Architect's Supplemental Instructions (ASI) 008 Bulletin

Project: Arvada/Ralston Creek

The Sheets listed below reflect revisions to the Buildings 2 & 4, Sub-Metering. JSE revised electrical riser diagrams to meet field conditions and Ownership requirements. These revisions are captured in the sheet below. Revisions are clouded with Delta 34.

1 BUILDING 2&4 - RISER DIAGRAM
Scale: NTS

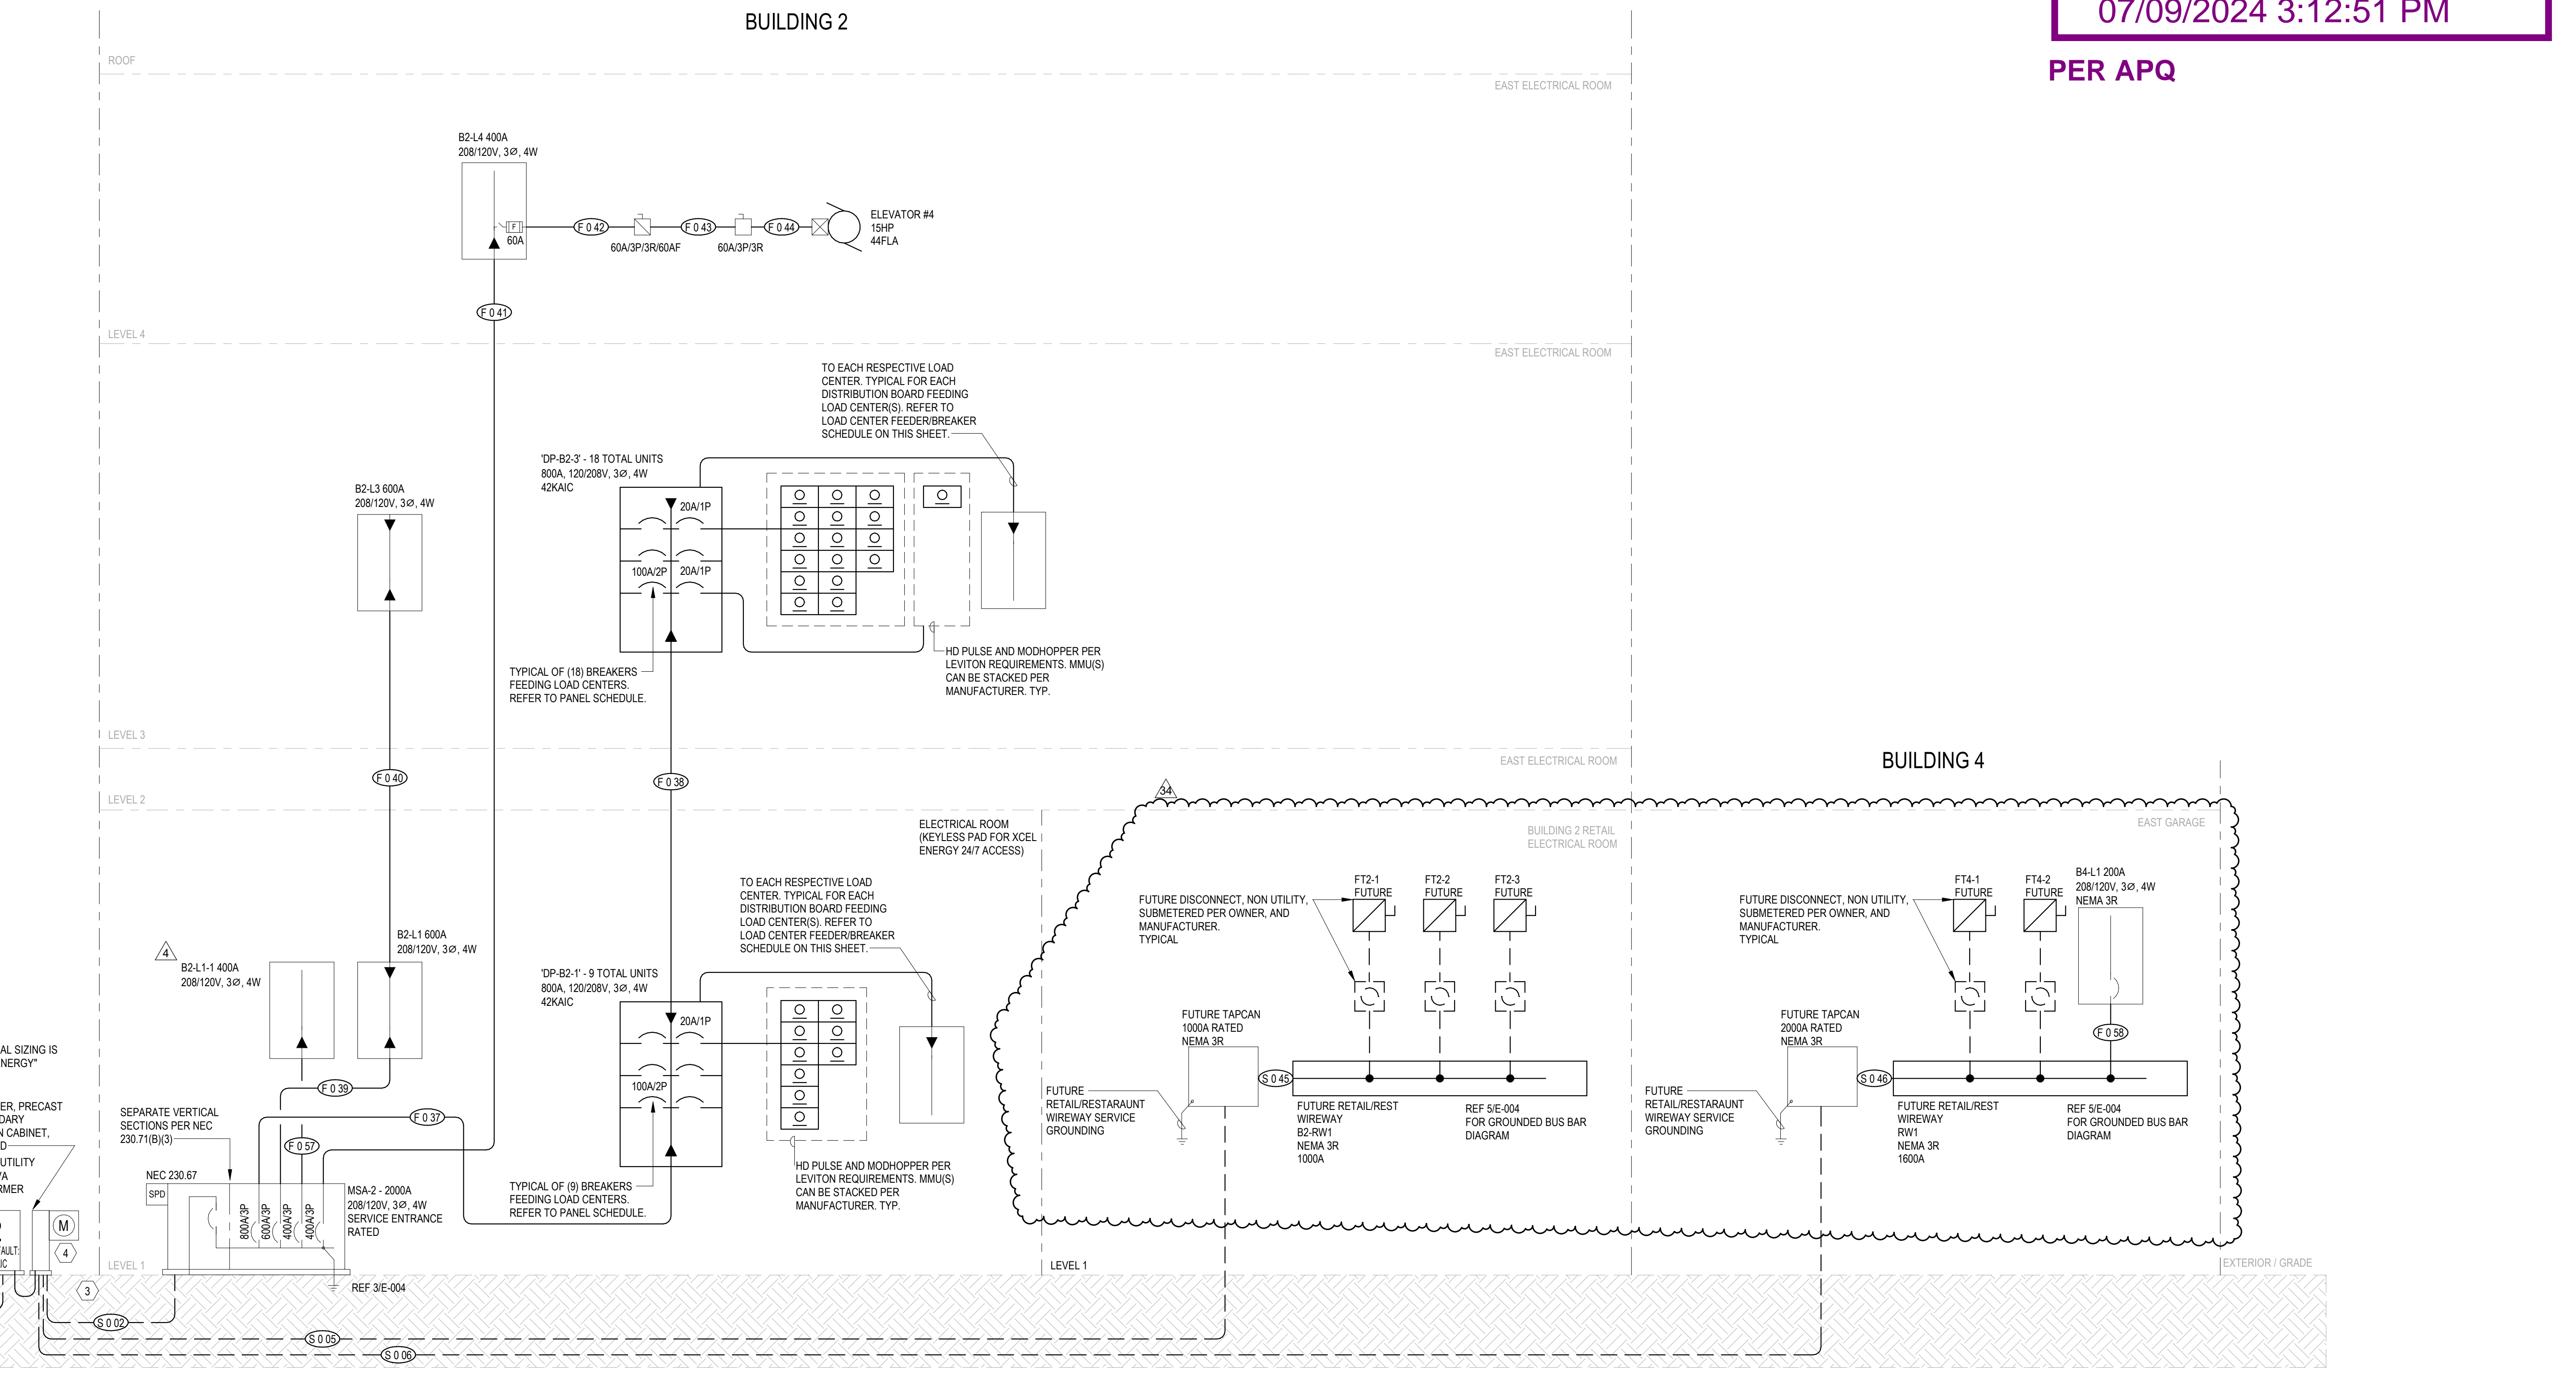
E0-06C RISER DIAGRAMS: Sub-Metering to be installed by 3rd party and not construction team.
